## **Merged Document Report**

**Application No.: PL8707**

| Record Type : | PLAT |

# PRELIMINARY PLAT OF NEMEC TOWNE CENTER PHASE 2 BLOCK 1

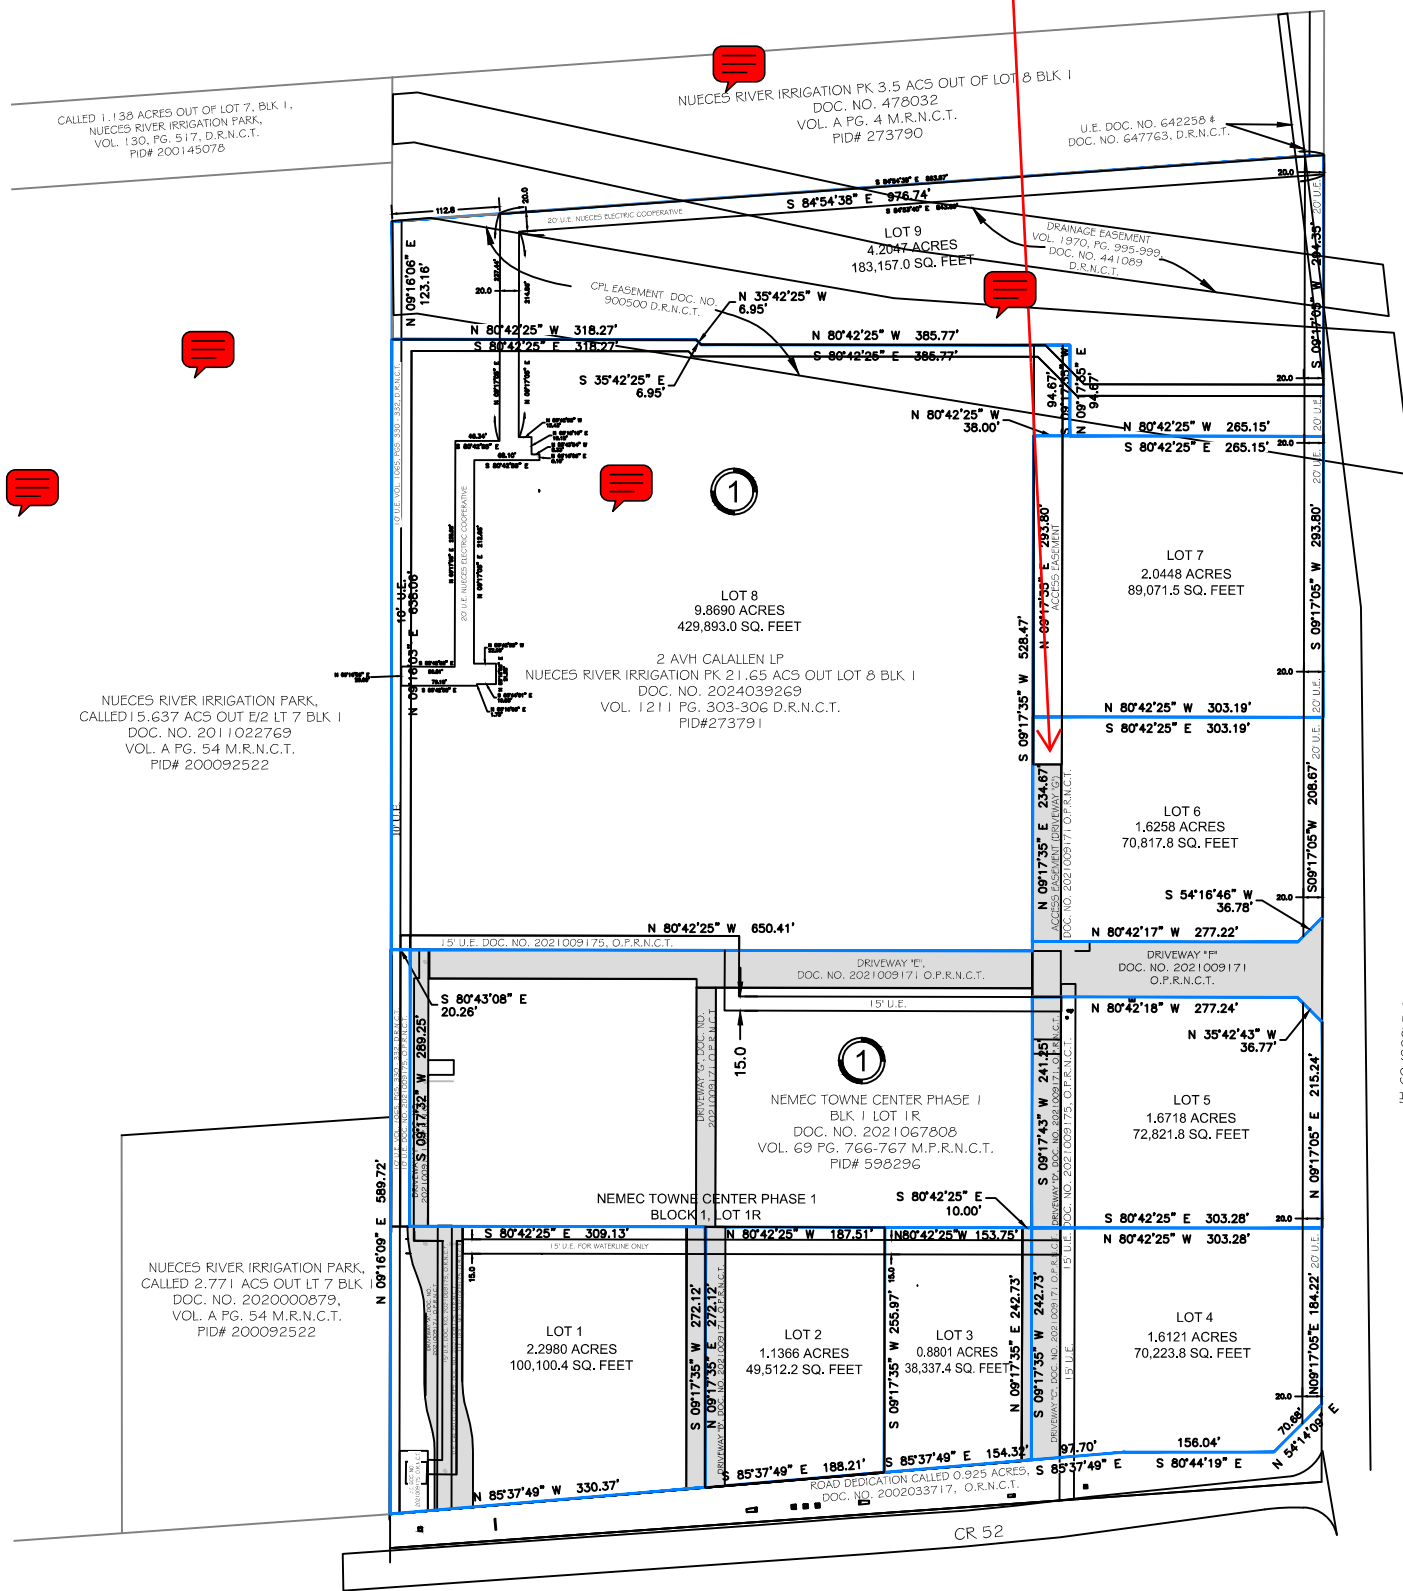
| Comment ID | Page Reference | Annotation Type | Author : Department | Status | Review Comments   | Applicant Response Comments |
|------------|----------------|-----------------|---------------------|--------|---|-----------------------------|
| 19         | Plat           | Note            | Alex Harmon : DS    | Closed | Provide private drainage easement for detention ponds, or place a note that Lot 9 is non-buildable.   |                             |
| 20         | Plat           | Callout         | Alex Harmon : DS    | Closed | Should this plat extend the access easement to Lot 7 and/or 9 or will Lot 7 and/or 9 have access along frontage only?   |                             |
| 21         | Plat           | Note            | Alex Harmon : DS    | Closed | Place 20 ft UE along lots 4-7 and Lot 9 along IH-69 frontage road.  |                             |

Should this plat extend the access easement to Lot 7 and/or 9 or will Lot 7 and/or 9 have access along frontage only?
